# Technical Support Document:

## Chapter 24

### Intended Round 3 Area Designations for the 2010 1-Hour SO<sub>2</sub> Primary National Ambient Air Quality Standard for the Navajo Nation

**Figure 15: Predicted 99<sup>th</sup> Percentile Daily Maximum 1-Hour SO<sub>2</sub> Concentrations Averaged Over 5 Years for the Area of Analysis for the Navajo Nation Portion of Coconino County**  
**NGS 1-hr SO<sub>2</sub> 2008-2012 DV**

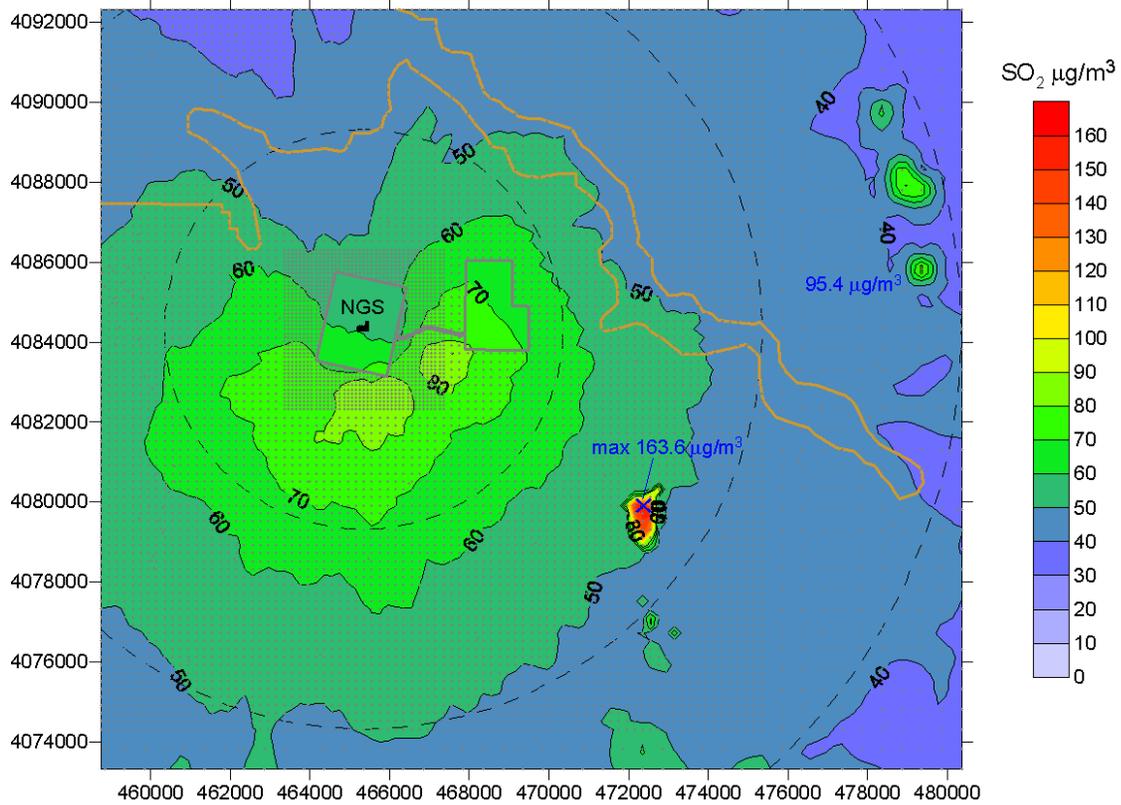
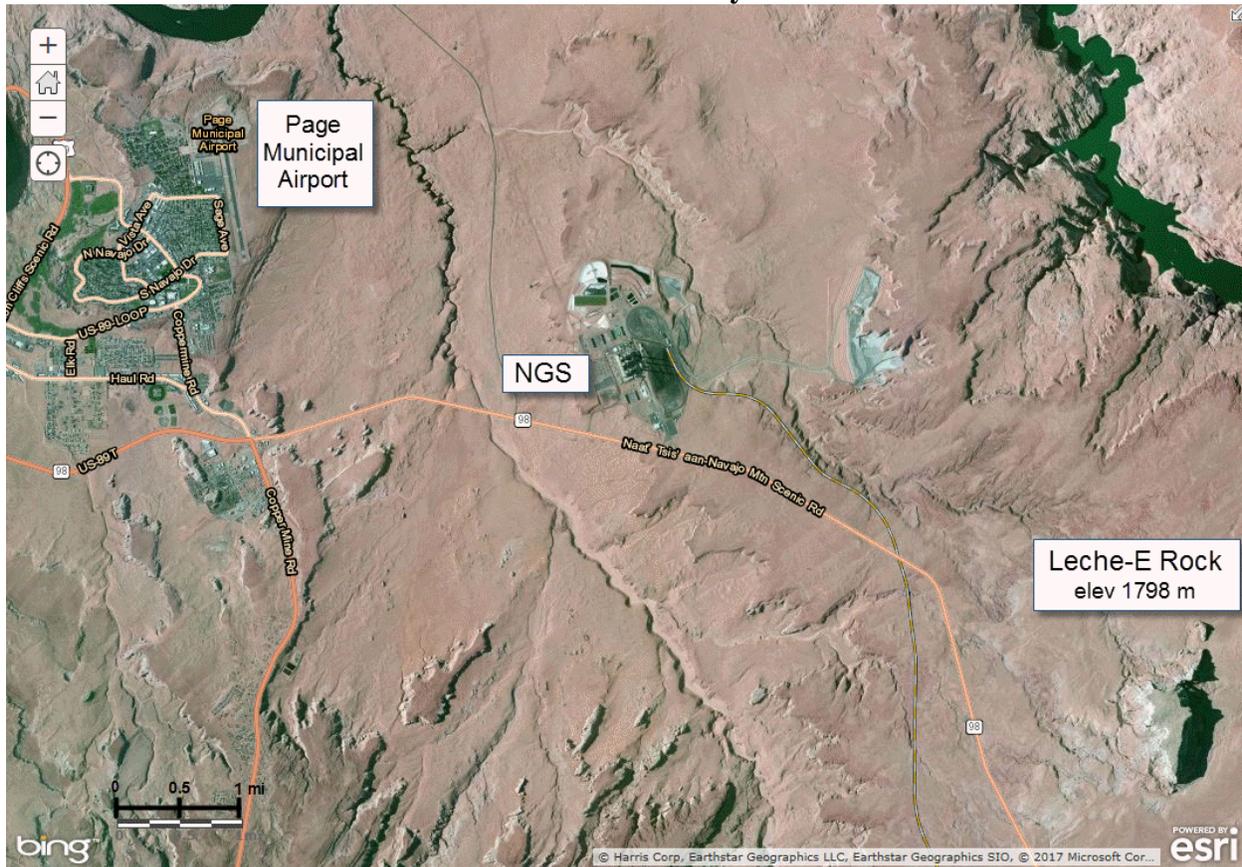
The Navajo Nation’s modeling indicates that the highest predicted 99<sup>th</sup> percentile daily maximum 1-hour concentration within the chosen modeling domain is 163.6 µg/m<sup>3</sup>, equivalent to 62.5 ppb. This modeled concentration included the background concentration of SO<sub>2</sub>, and is based on an estimate of average annual emissions from the facility. Figure 15 below is a version of one that was included as part of the Navajo Nation’s analysis, and indicates that the predicted value occurred 8.3 km southeast of NGS. This maximum appears to coincide with Leche-E Rock, which rises abruptly to an elevation of 1,798 m. Figure 16 shows an image of this topographic feature. The Navajo Nation’s receptor grid is also shown in Figure 15.

The modeling submitted by the Navajo Nation indicates that the 1-hour SO<sub>2</sub> NAAQS is not violated at the receptor with the highest modeled concentration.
